LOGISTICS PARK KANSAS CITY (LPKC) SOUTH, FOURTH PLAT

Application FS2022-01

FINAL SITE PLAN REVIEW

Staff has reviewed the Final Site Plan submittal for compliance with the requirements in Section 10.1 of Article 10 and Section 5.2 of Article 5 of the Edgerton Unified Development Code (UDC). Review comments are as follows:

TRAFFIC IMPACT STUDY

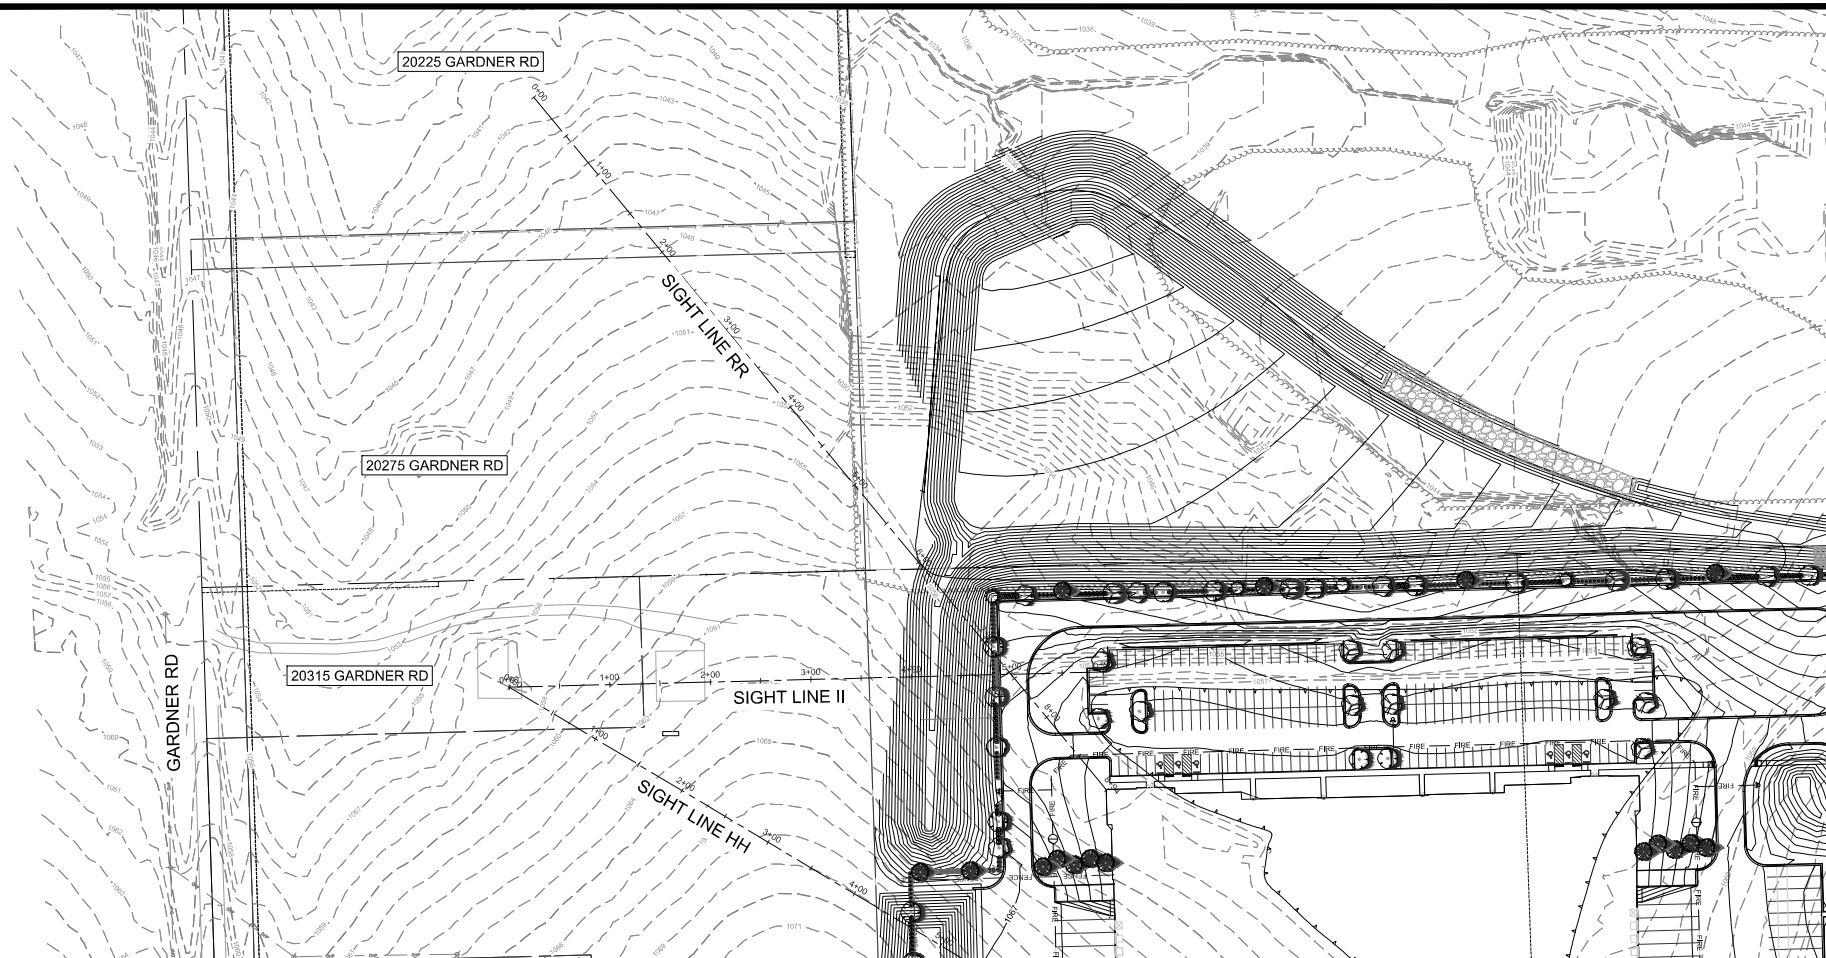
1. A data table which, at a minimum, includes: acreage of the site and number of units per acre (if applicable), gross square feet of the building(s) area, the proposed use of each building, number of employees and the total number of parking spaces to be provided.
 - a. *Several parking stalls were removed to add additional berming and landscaping on the west side of the project site. The submitted Final Site Plan does not reflect the changes shown in the Line of Sight drawings submitted for the project.*

- i. *The applicant has provided Line of Sight Drawings showing the screening of the trucks and chassis from multiple vantage points from neighboring properties. All landscaping and berms must be maintained to ensure this requirement is met at all times.*
- ii. *The applicant has included a vinyl shadow box fence to be used along the east side of the property to ensure effective screening is accomplished. All fencing must be maintained to ensure this requirement is met at all times.*

Update Final Site Plan to match the Line of Sight Drawings.

Applicant acknowledges.
